NASA Engineering and Safety Center Technical Report	Document #: RP-07-49	Version: 1.0
Title: DAWN Mission Bus and Waveguide Venting Analysis Review			Page #: 1 of 36

DAWN Mission Bus and Waveguide Venting Analysis Review

May 24, 2007

Figure 7.4-4. DAWN Bus External (Approximately Internal) Pressure Profile [ref. 4]

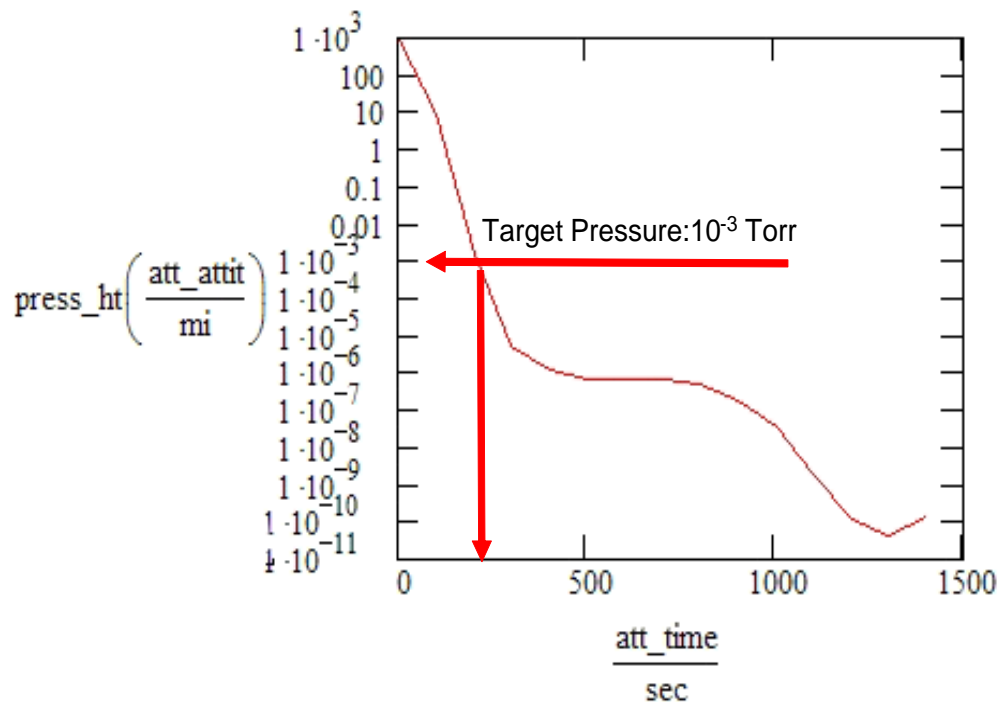
Both of the venting analyses appear correct from atmospheric pressure down to about 10^{-2} or 10^{-3} Torr; 10^{-2} Torr is all that is required for safe activation of the TWTA. It is not clear if the analysis below 10^{-3} Torr, in particular in the neighborhood of 10^{-5} Torr, inside the waveguide is correct since outgassing in a body with small vent holes can require days to complete. This is not a factor for this analysis due to the requirement of 10^{-2} Torr, but curves showing pressures of 10^{-5} Torr and below can cause confusion.
